## Manuscript AMT-2022-288

### Reply to Anonymous Referee #1

*Referee comment on "Optical receiver characterisations and corrections for ground-based and airborne measurements of spectral actinic flux densities" by Birger Bohn and Insa Lohse, Atmos. Meas. Tech. Discuss., <https://doi.org/10.5194/amt-2022-288-RC1>, 2022*

New figure X: "Top and bottom receiver positions of the three HALO configurations FLT, FLN and FLV. Adapted from a figure used with permission by DLR, Germany."

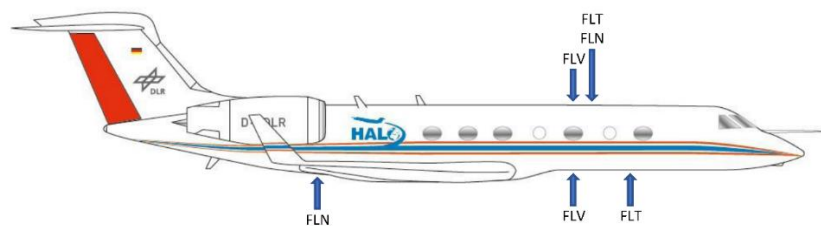
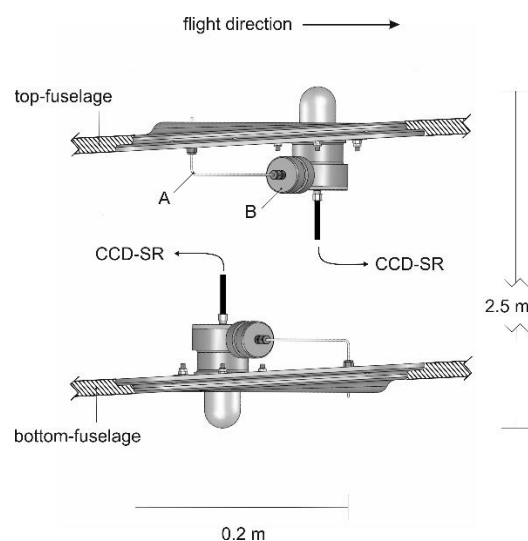
Lines 114-5: I do not see a description of FLT, FLV and FLN. Nor do I understand the acronyms. Figure S7 does give some information but does not distinguish between FLT and FLN.

Reply: The acronyms were originally chosen to distinguish between ground and airborne configurations: GRD for "ground" and FLT for "flight". In a subsequent deployment the "nadir" receiver position was changed, and this configuration was named FLN. In another campaign both receivers were placed in the larger "viewport" adapters (Fig. S7) of HALO which led to the acronym FLV. We don't think the reader should be bothered with this acronym history. On the other hand, we noticed that the acronyms GRD and ZEPP\_FLT were not mentioned in the manuscript but are used in some of the file names in the online material. We therefore added a sentence in the Supplement, page 14 line 27 to clarify: "The configurations can be inferred from the filenames: GRD refers to corrections for the four receivers on the ground, ZEPP\_FLT to the Zeppelin configuration, and HALO\_FLT, HALO\_FLN and HALO\_FLV refer to the three HALO configurations." Moreover, we added a new figure (see below) after Fig. 2 showing the receiver positions of the three HALO configurations and added one sentence in line 117: "The receiver positions of the three configurations are indicated by arrows in Fig. X."

In addition, we reversed the flight direction of the setup in Fig. 2 to match with the new figure above.

Revised Fig. 11: "... Cloud layers are indicated by grey-shaded areas..."

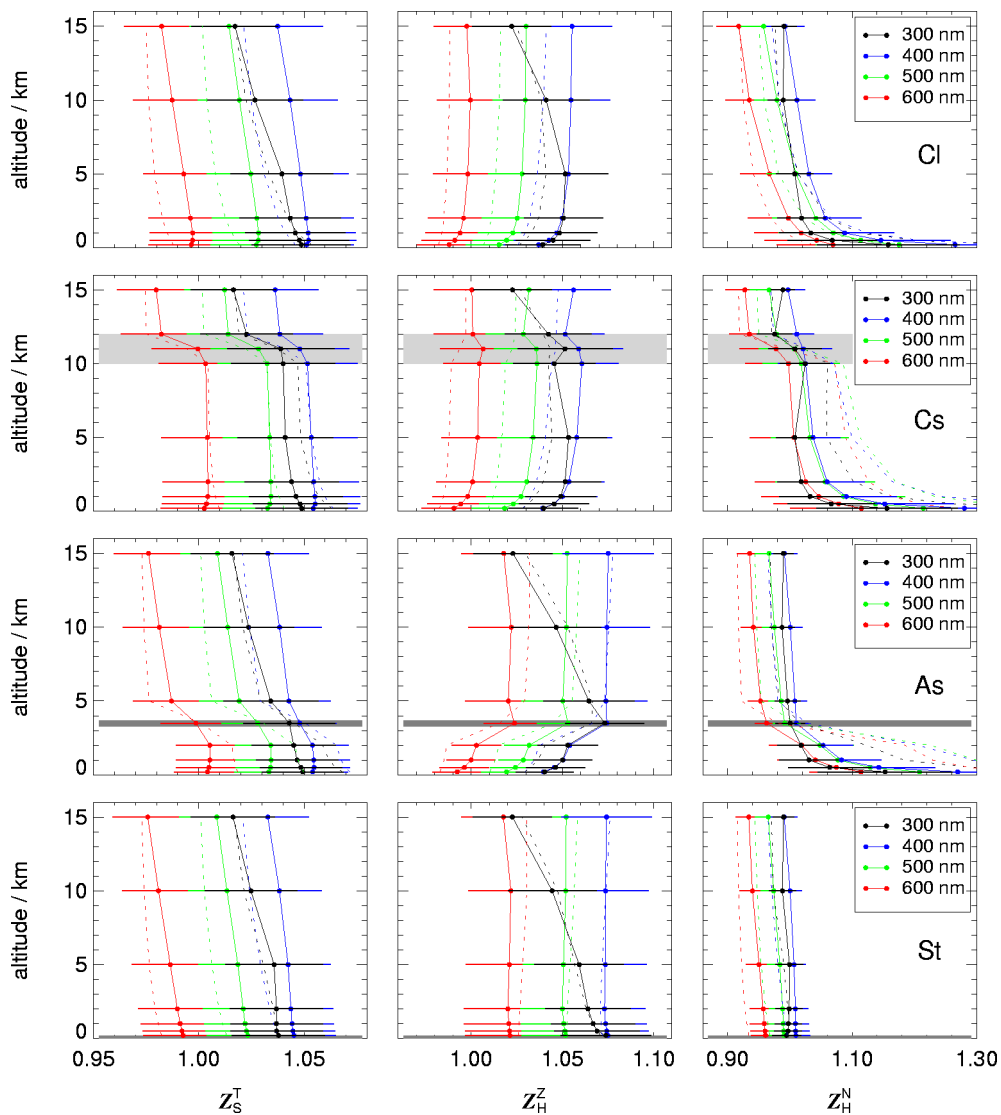
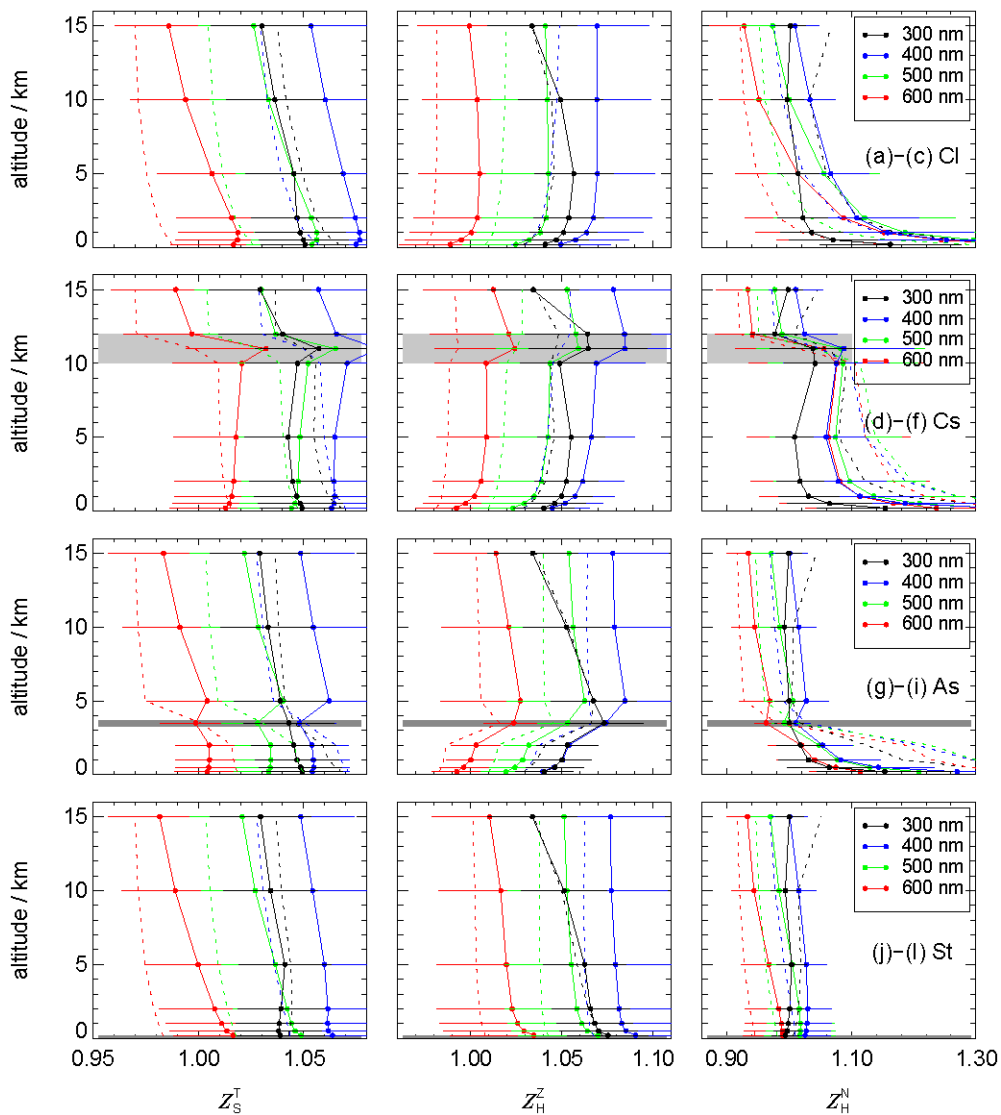
Figures 11 and S27: The grey bars for the Cs cloud in these figures are deceiving. The cloud ranges from 10-12 km but is shown as a thin line at 11 km. I also suggest adding a point at 12 km to show the correction from the bottom to the top of the cloud.

Reply: As suggested, we made additional simulations and derived corrections for the cirrus cloud case at 12 km. The figures were revised, and the cloud covers were included more realistically by grey areas indicating their depths (see revised Fig. 11 and Fig. S27 below). The 12 km corrections are close to those at 15 km and will not be used for the parameterizations (like the in-cloud corrections). In line 472 we added: "...at the intermediate altitudes of 3.5 km (As) and 11 km (Cs) as well as from above-cloud at 12 km (Cs) were not considered..." The 12 km data were included in version 2 of the online material.

Revised Fig. S27: "... Cloud layers are indicated by grey-shaded areas..."

Revised Fig. 17: "... The color-coded error bars correspond to total uncertainties including those from corrections and calibrations (Sect. S7, Supplement). The overlying grey error bars indicate the uncertainties from the corrections alone."

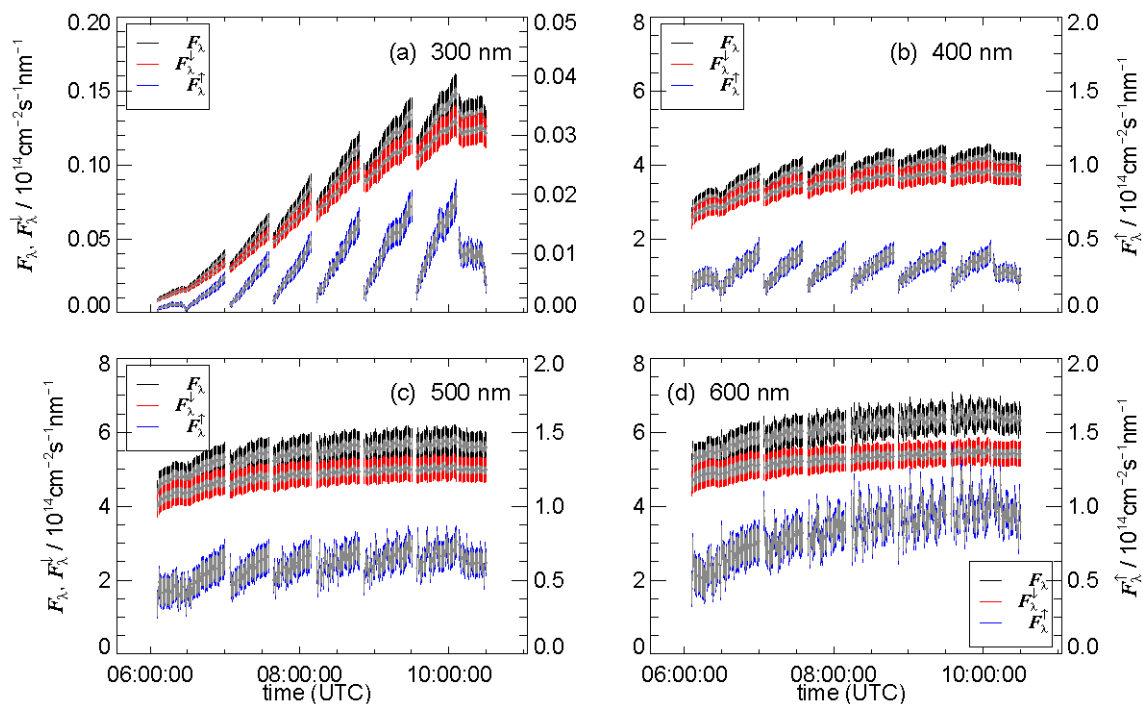
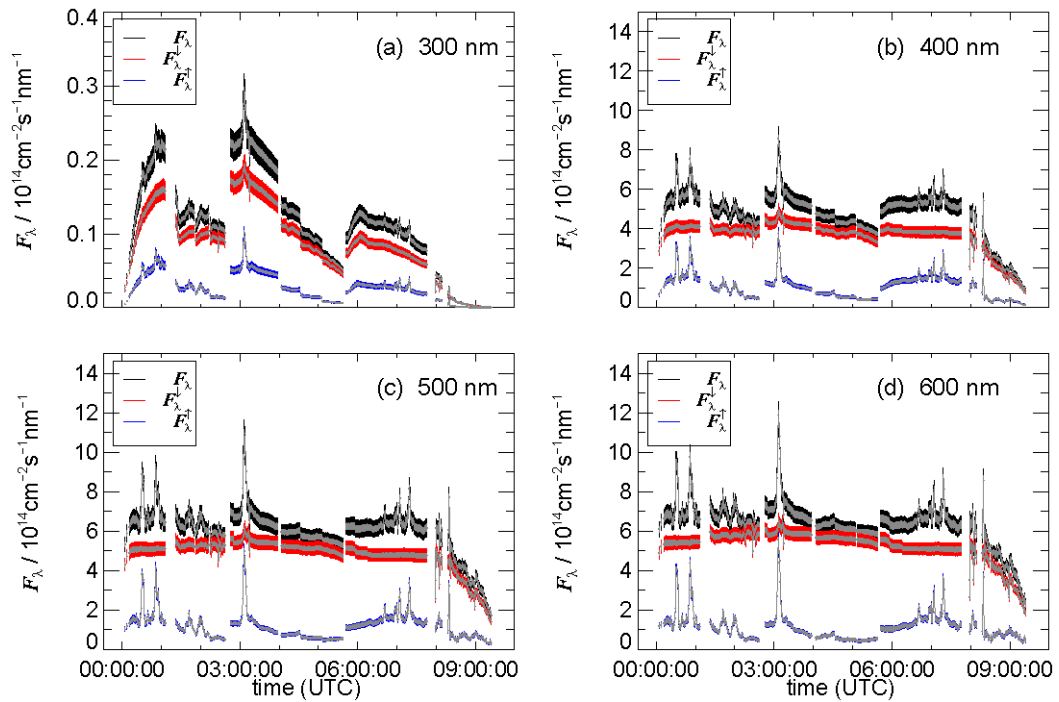
Figure 17: The error bars show the uncertainties from the corrections and calibrations. I was disappointed not to see the impact of the corrections alone as that is the point of the entire paper. It should be shown in this figure (or another) and well explained in the text. The fact that they may be relatively small (especially on this HALO flight) is important.

Reply: The uncertainties of the corrections are shown separately in Figs. 14 and 16 where they can be examined in greater detail. In Figs. 15 and 17 they are difficult to see for smaller values of the flux densities. Anyway, we now show both, total errors and those of the corrections alone as grey overlays. In the text we now write (line 502): "The finally derived total, downward and upward spectral actinic flux densities are shown in Fig. 15 together with their total uncertainties and those resulting from the corrections. The latter are dominant for the upward component and less significant for the total and downward." And in line 520 for HALO: "The finally derived spectral actinic flux densities and their uncertainties are shown in Fig. 17. The uncertainties from the corrections are again more significant for the  $F_{\lambda}^{\uparrow}$  especially at low altitudes. Flux densities ..."

Revised Fig. 15: ... The color-coded error bars correspond to total uncertainties including those from corrections and calibrations (Sect. S7, Supplement). The overlying grey error bars indicate the uncertainties from the corrections alone. ..."

Note that the date was removed from the x-axis ("time (UTC)" was added instead), the x-range was changed, y-ranges for 400, 500 and 600 nm are the same now and panels are labelled (a)-(d) in response to referee #2.

Note that the date was removed from the x-axis ("time (UTC)" was added instead), y-ranges for 400, 500 and 600 nm are the same now and panels are labelled (a)-(d) in response to referee #2.
